Millstone Nuclear Power Station, Unit No. 3

Technical Specifications Change Request 3-11-00
Reactor Coolant System Heatup and Cooldown Curves
Retyped Pages

**Technical Specifications Change Request 3-11-00
Reactor Coolant System Heatup and Cooldown Curves
Exemption Request from 10 CFR 50.60(a) and 10 CFR 50 Appendix G**

Millstone 3 Reactor Coolant System Heatup Limitations for Fluence up to $1.97\text{E}+19$ n/cm (32 EFY)

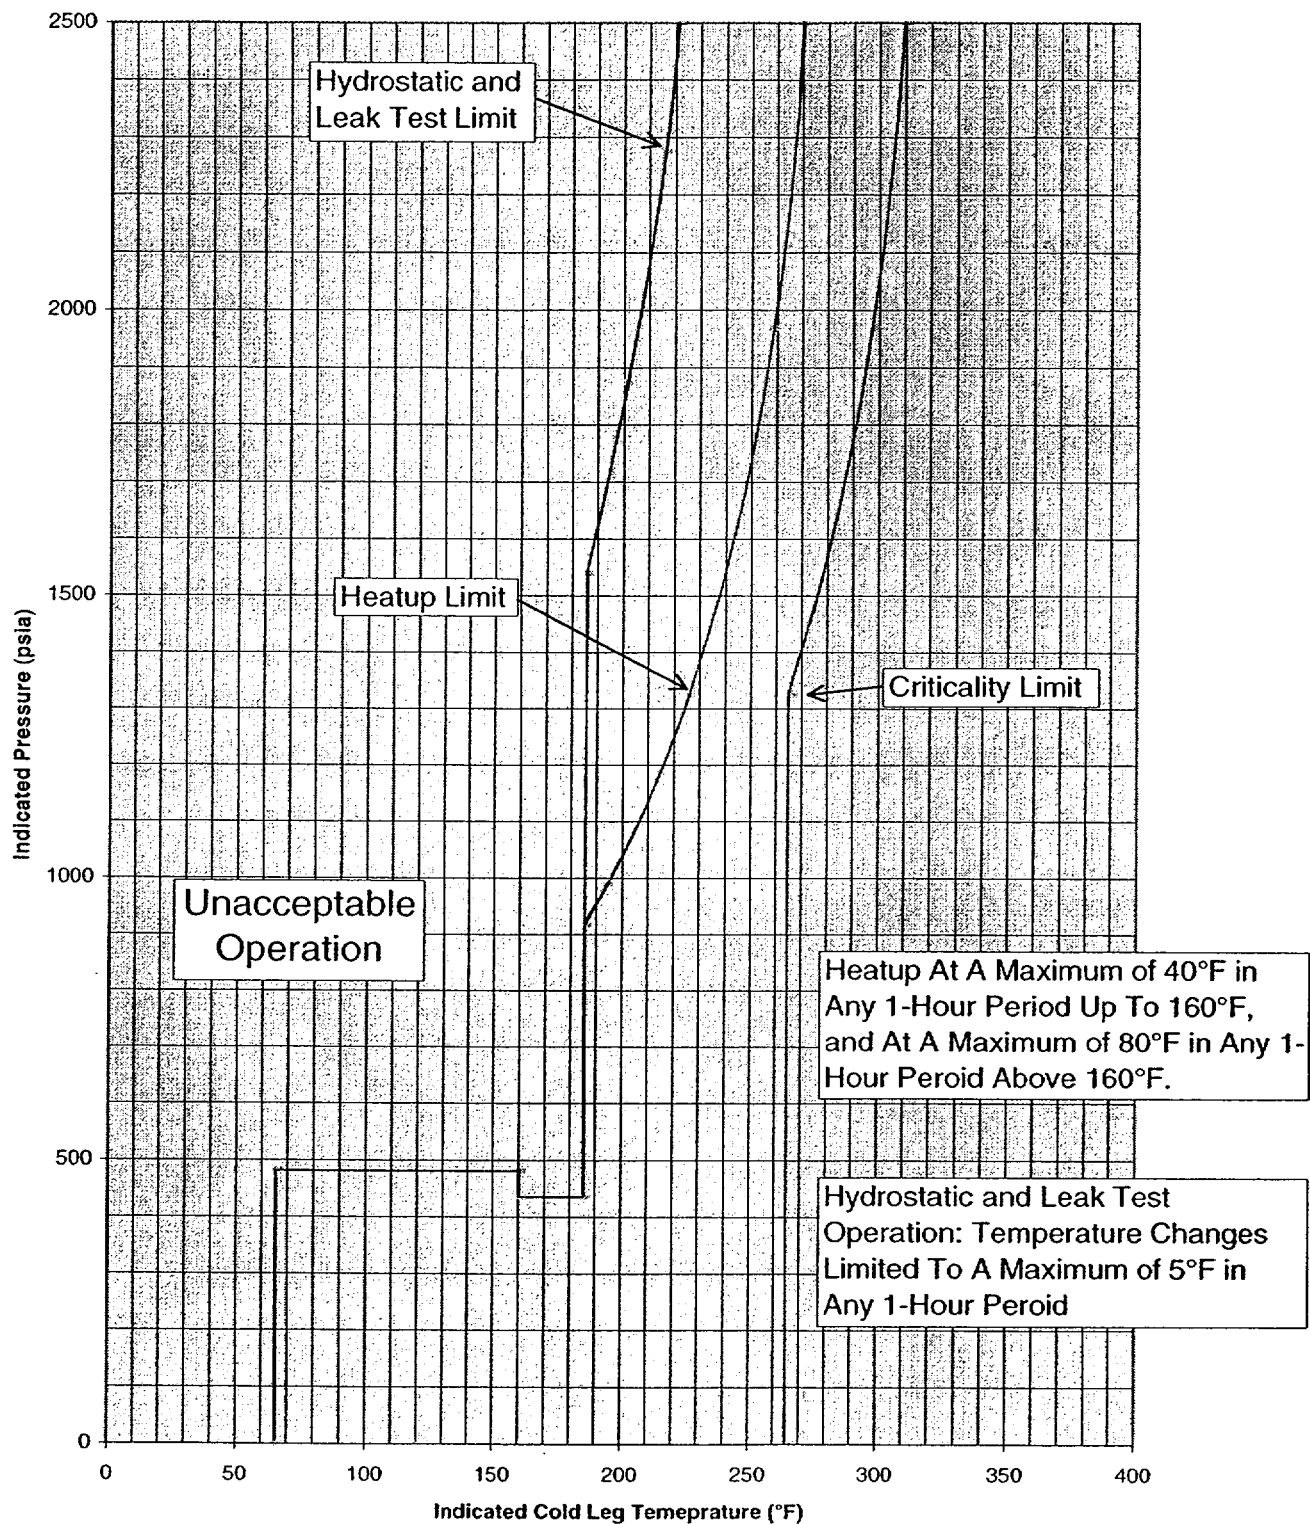
3.4.9.1 Reactor Coolant System (except the pressurizer) temperature, pressure, and heatup and cooldown rates of ferritic materials shall be limited in accordance with the limits shown on Figures 3.4-2 and 3.4-3. In addition, a maximum of one reactor coolant pump can be in operation when the lowest unisolated Reactor Coolant System loop wide range cold leg temperature is $\leq 160^{\circ}\text{F}$.

Figures 3.4-2 and 3.4-3 contain P/T limit curves for heatup, cooldown, inservice leak and hydrostatic (ISLH) testing, and data for the maximum rate of change of reactor coolant temperature.

Millstone 3 Reactor Coolant System Cooldown Limitations for Fluence up to $1.97\text{E}+19$ n/cm (32 EFY)

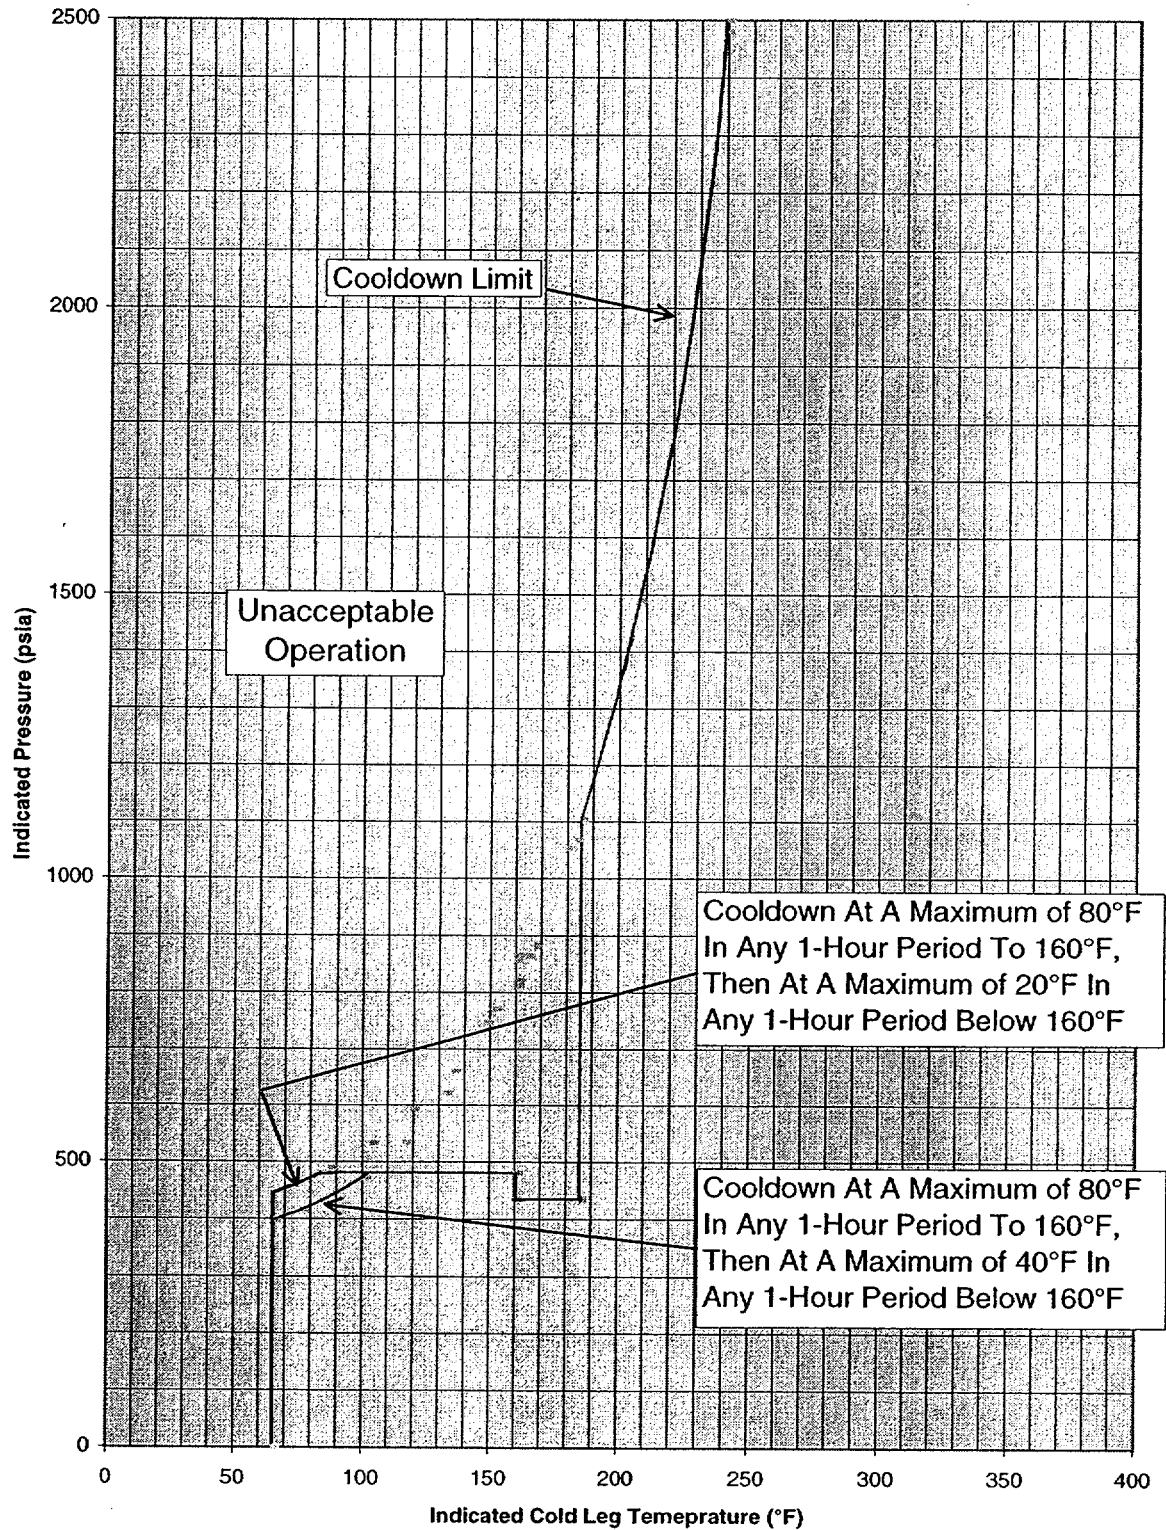
Verification that operation is within the LCO limits as well as the limits of Figures 3.4-2 and 3.4-3 is required every 30 minutes when RCS pressure and temperature conditions are undergoing planned changes. This frequency is considered reasonable in view of the control room indication available to monitor RCS status.

High Setpoint PORV Curve For the Cold Overpressure Protection System

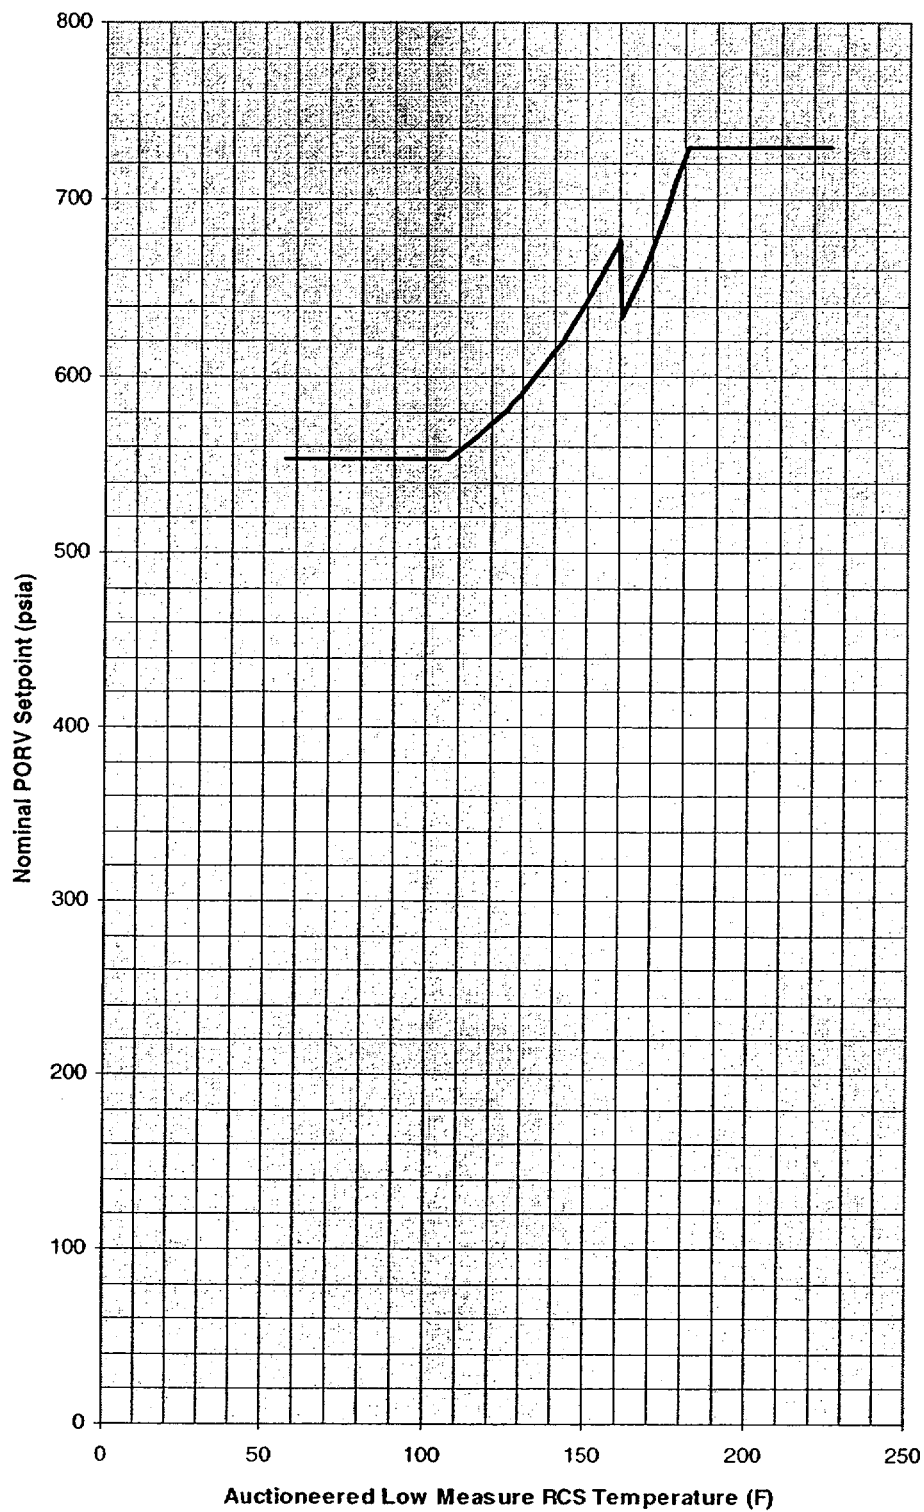
1. One power operated relief valve (PORV) with a nominal lift setting established in Figure 3.4-4a and one PORV with a nominal lift setting established in Figure 3.4-4b with no more than one isolated RCS loop, or
2. Two residual heat removal (RHR) suction relief valves with setpoints ≥ 426.8 psig and ≤ 453.2 psig, or
3. One PORV with a nominal lift setting established in Figure 3.4-4a or Figure 3.4-4b with no more than one isolated RCS loop and one RHR suction relief valve with a setpoint ≥ 426.8 psig and ≤ 453.2 psig, or
4. RCS depressurized with an RCS vent of ≥ 2.0 square inches.

Figure 3.4-4a and Figure 3.4-4b present the PORV setpoints for COPPS. The setpoints are staggered so only one valve opens during a low temperature overpressure transient. Setting both valves to the values of Figure 3.4-4a and Figure 3.4-4b within the tolerance allowed for the calibration accuracy, ensures that the isothermal P/T limits will not be exceeded for the analyzed isothermal events.

The analyses show that the vessel is protected against non-ductile failure when the PORVs are set to open at the values shown in Figures 3.4-4a and 3.4-4b within the tolerance allowed for the calibration accuracy. The curves are derived by analyses for both three and four RCS loops unisolated that model the performance of the PORV cold overpressure protection system (COPPS), assuming the limiting mass and heat transients of one centrifugal charging pump injecting into the RCS, or the energy addition as a result of starting an RCP with temperature asymmetry between the RCS and the steam generators. These analyses consider pressure overshoot beyond the PORV opening setpoint resulting from signal processing and valve stroke times.
